**TO:** Jeanne Shaffer, Groundwork Entitlement Services, LLC  
**FROM:** BrieAnna Simon, Associate Planner  
**DATE:** March 13, 2020  
**SUBJECT:** SP19-062, Site Plan, Horseshoe Ridge Block 1 Lot 2 - Multi-Tenant Commercial Review Comments v3

# PARKER MIXED-USE RETAIL

LOT 2, BLOCK 1, HORSESHOE RIDGE SUBDIVISION 1ST AMENDMENT  
 A PARCEL OF LAND LOCATED IN THE SE 1/4 OF SECTION 28, TOWNSHIP 6 SOUTH, RANGE 66 WEST OF  
 THE 6TH PRINCIPAL MERIDIAN  
**SITE PLAN REVIEW**

SHEET: **A-1**

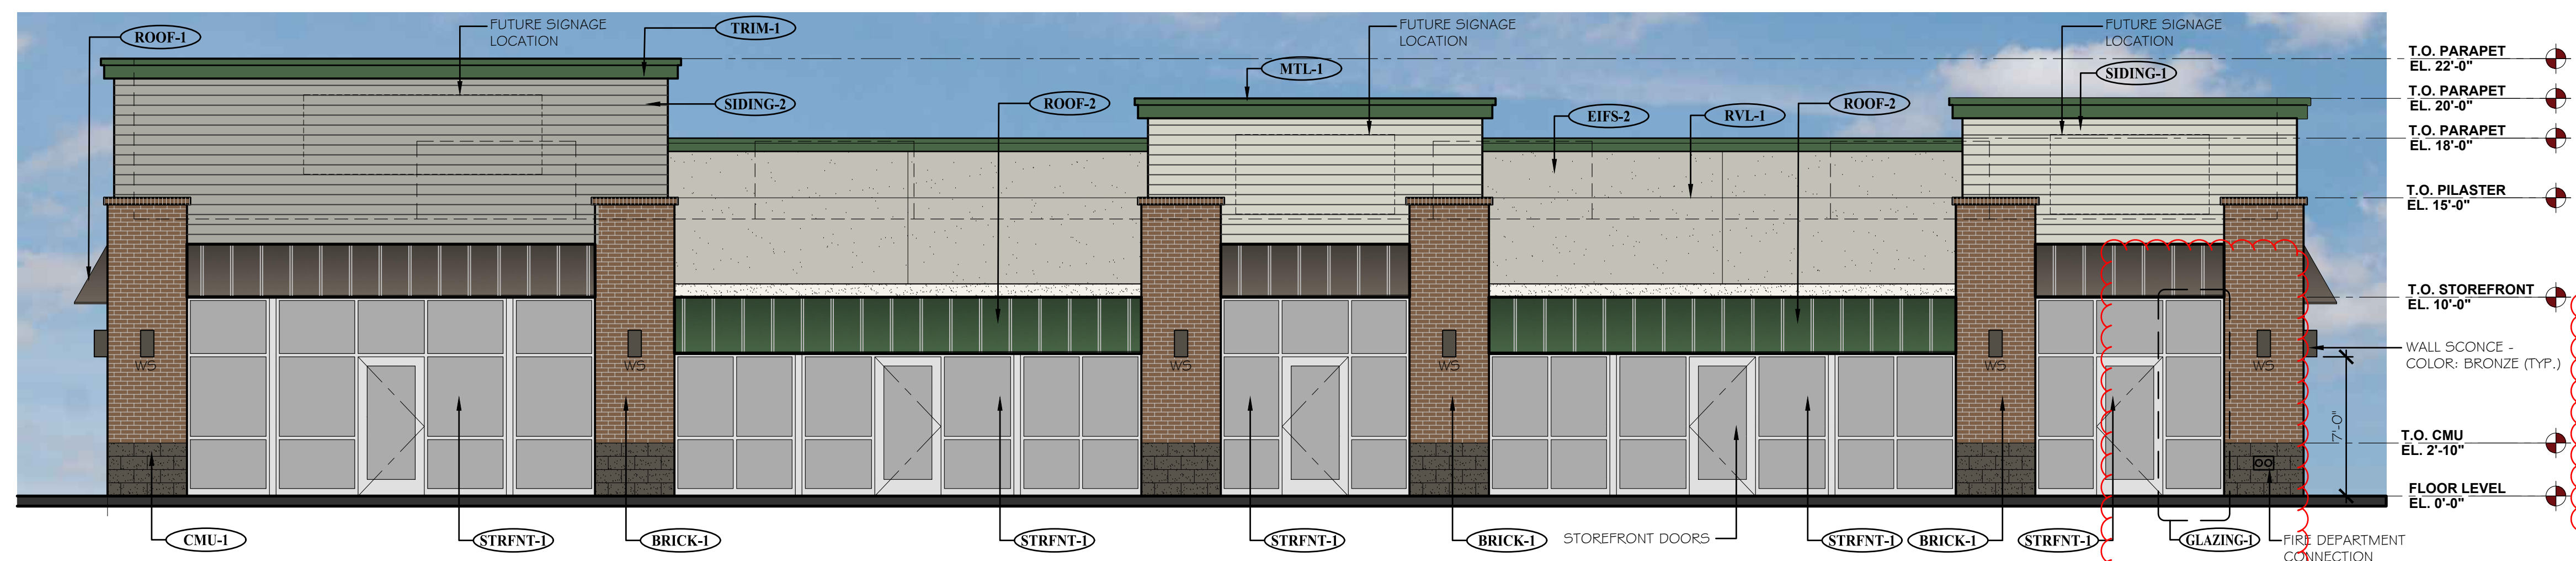
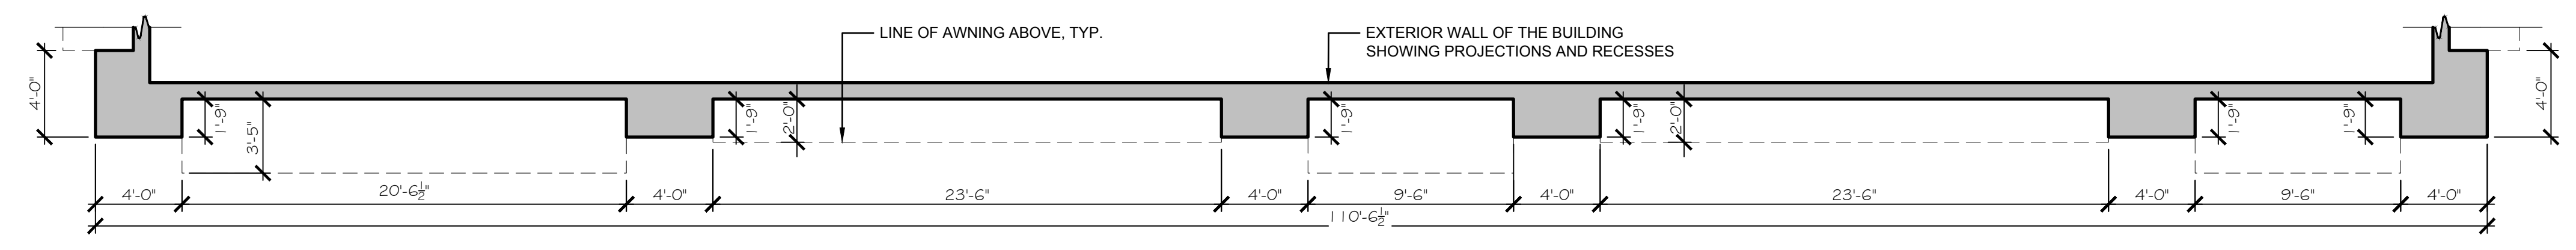
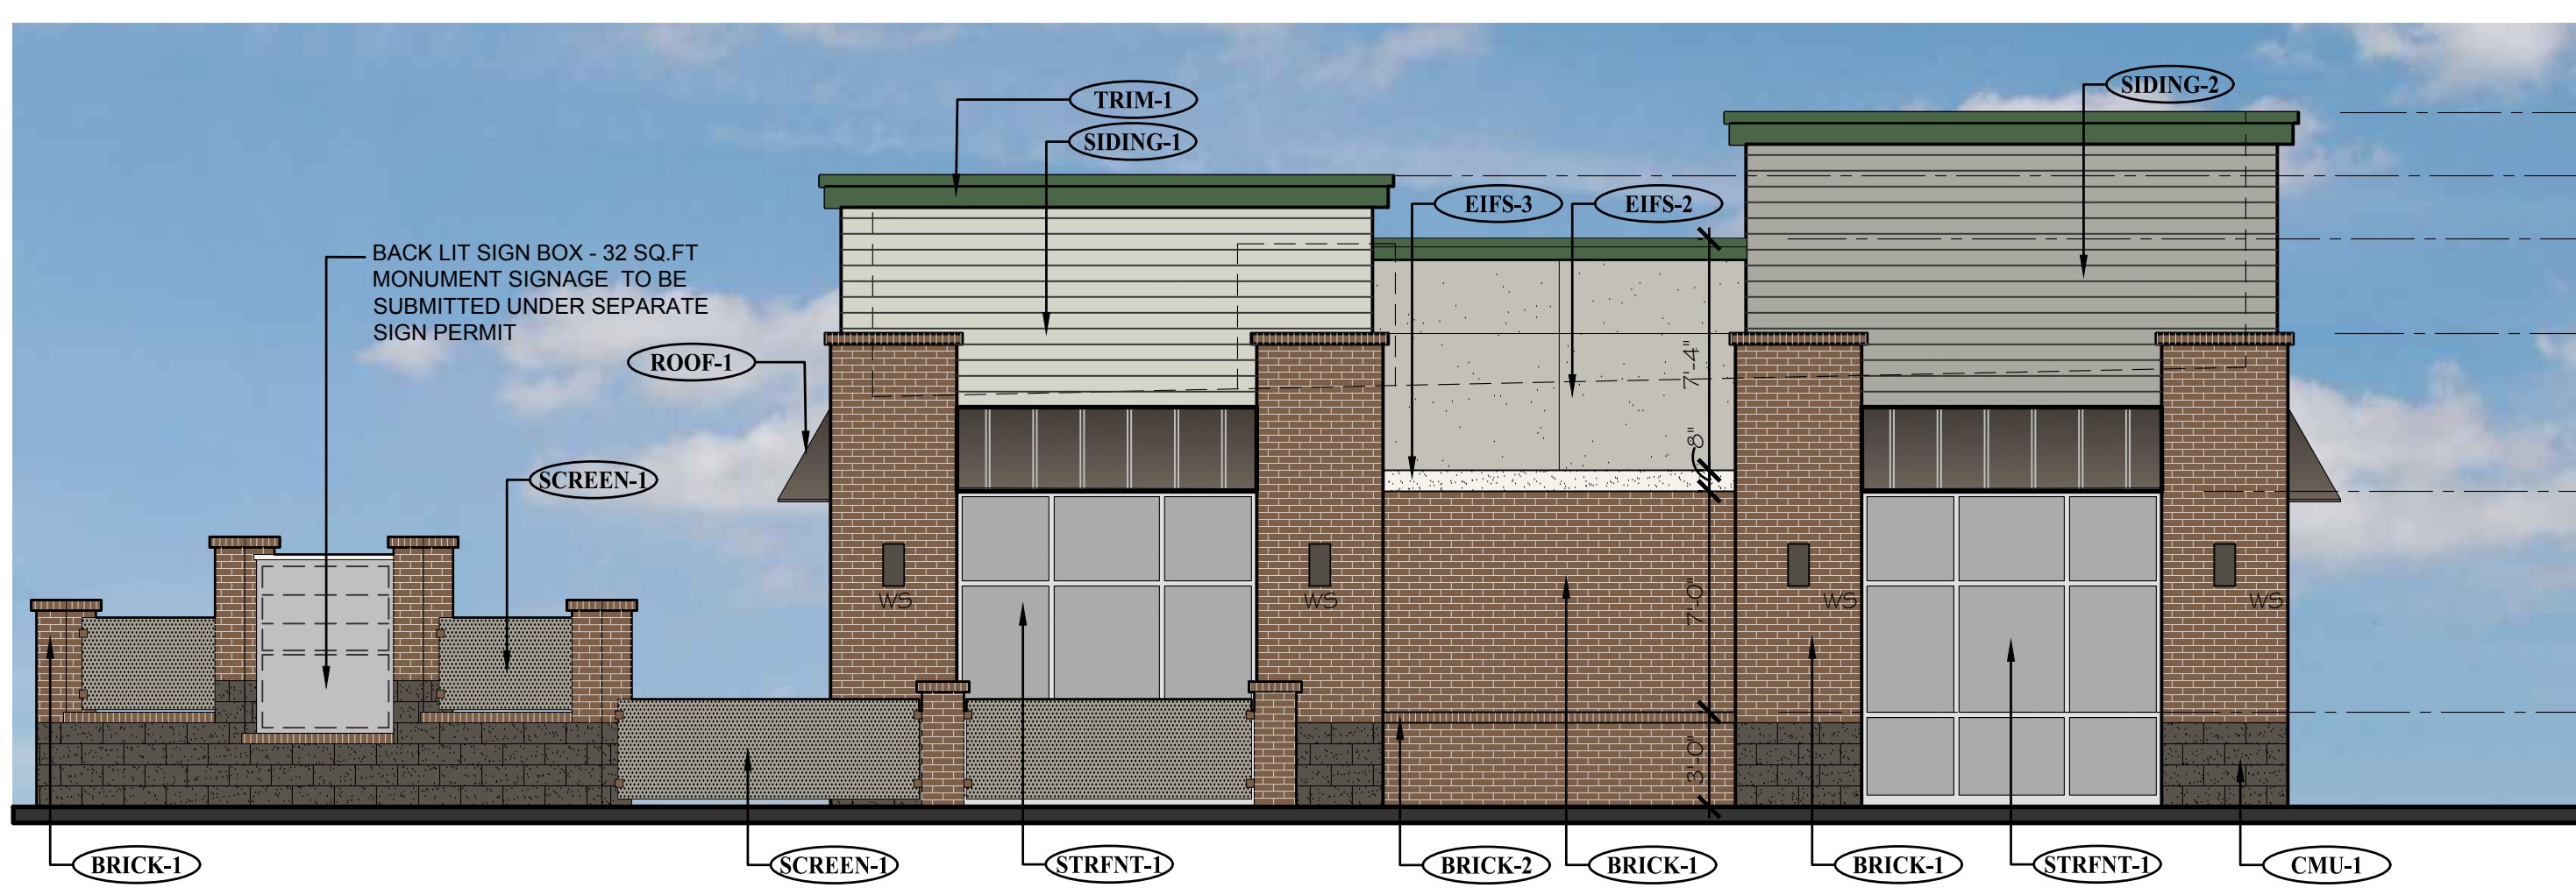
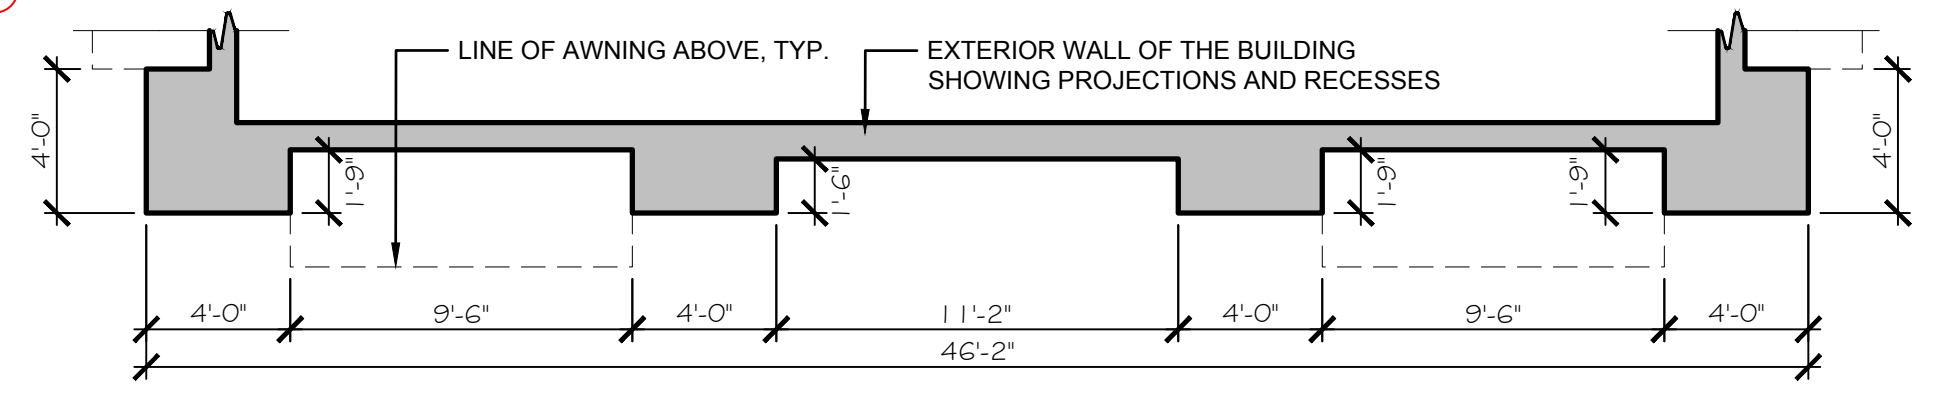
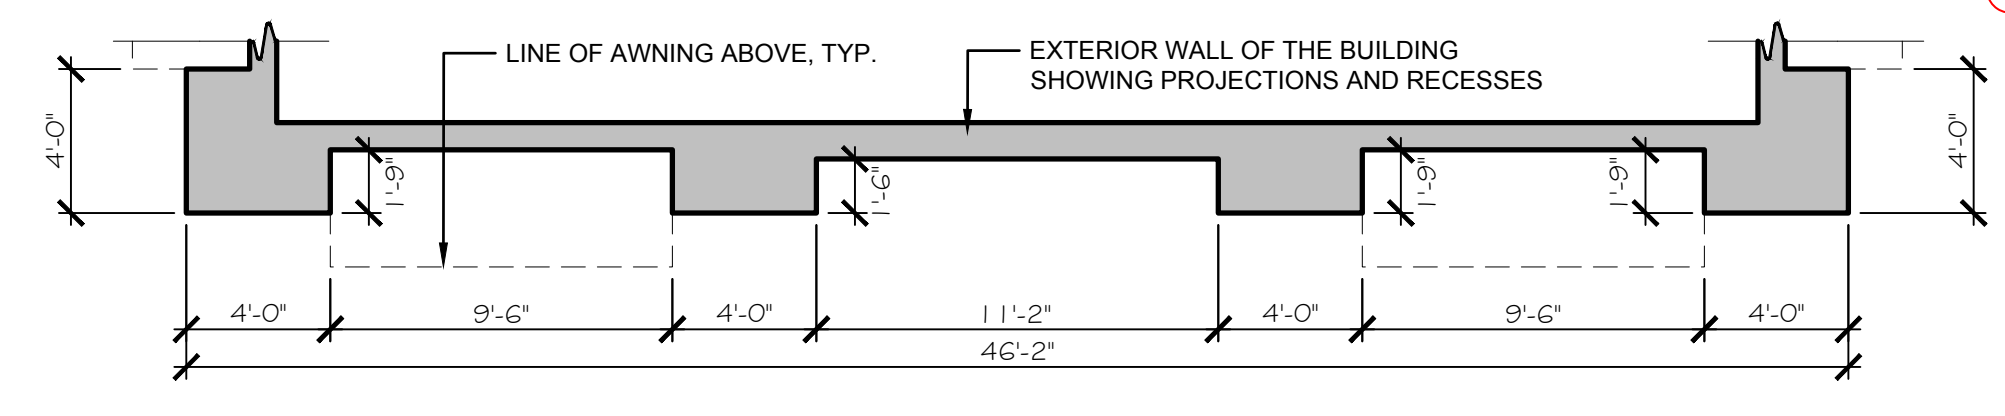
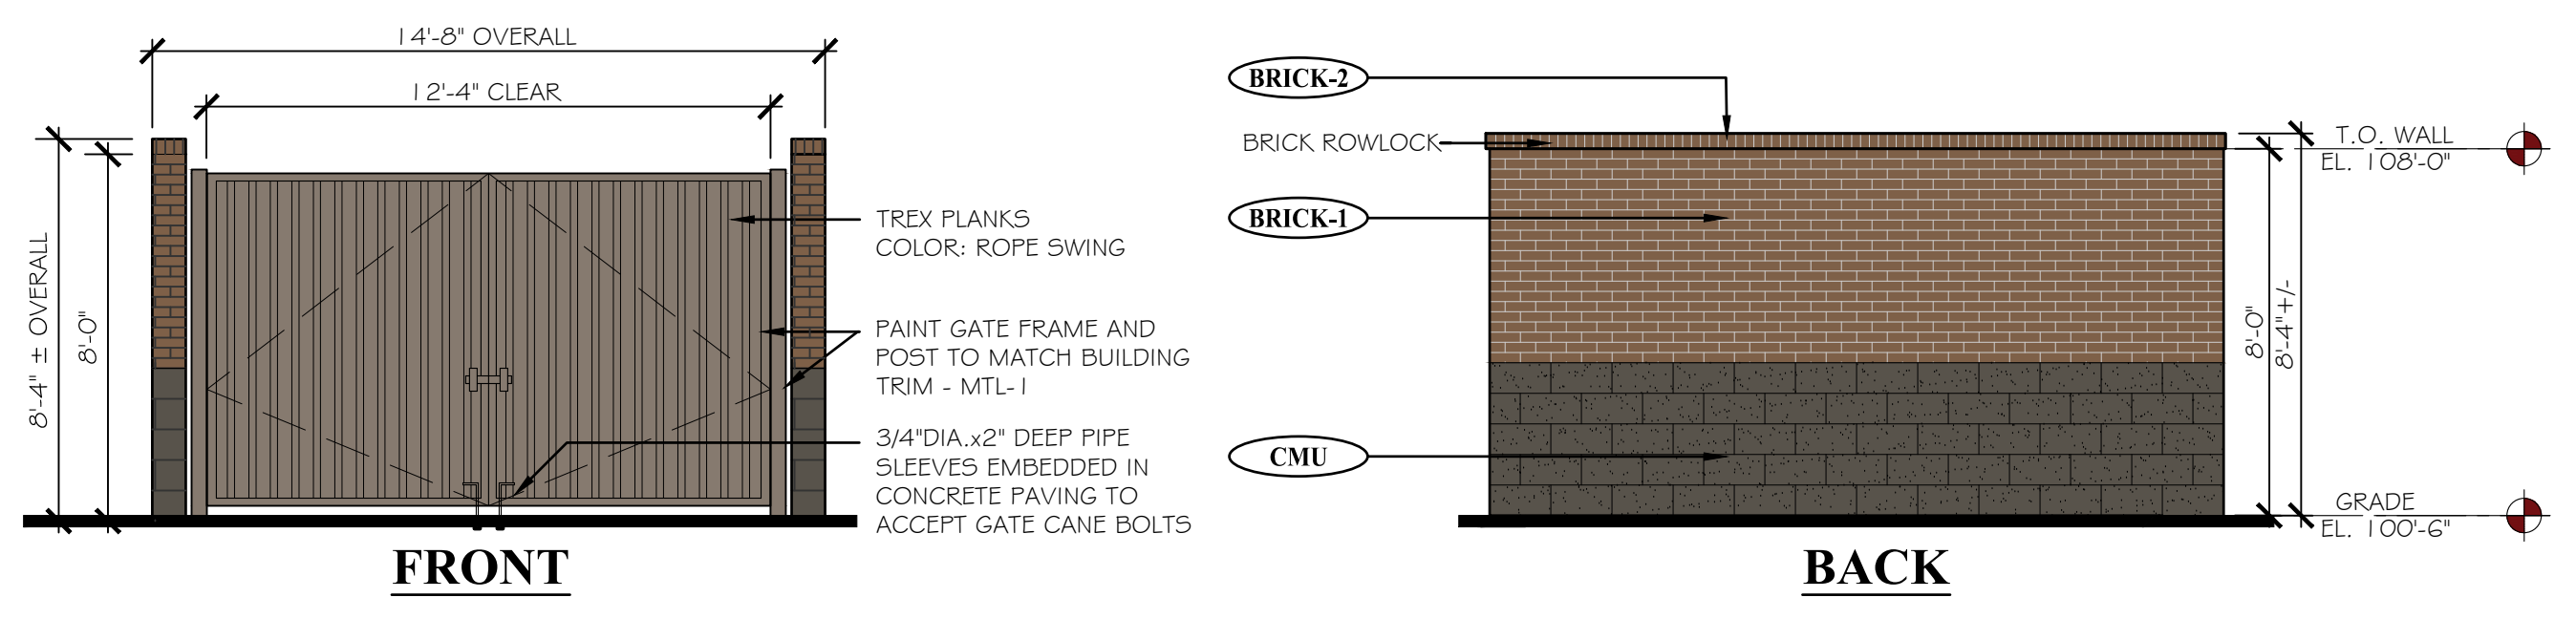
Remove comment. Do you have a floor plan for these tenant spaces? Will this proposed elevation work for kitchens, bathrooms, storage, etc.? Please call staff to discuss this elevation before resubmitting.

No glazing will be permitted on the north elevation for consistency.

NOTE:  
GLASS TREATMENT FOR STOREFRONT DOORS AND WINDOWS NOTED AS "GLAZING-1" SHALL BE COMPLETED BY THE TENANT BASED ON THE FLOOR PLAN DESIGN. PROPOSED OPTIONS FOR THESE STOREFRONT DOORS AND WINDOWS WOULD BE:  
1. OPEN GLASS DISPLAY WALL FOR VISIBILITY IN THE STORE  
2. NON-SIGNAGE BASED GRAPHICS/ARTWORK APPLIED TO GLASS  
3. FROSTED/TRANSLUCENT FILM.
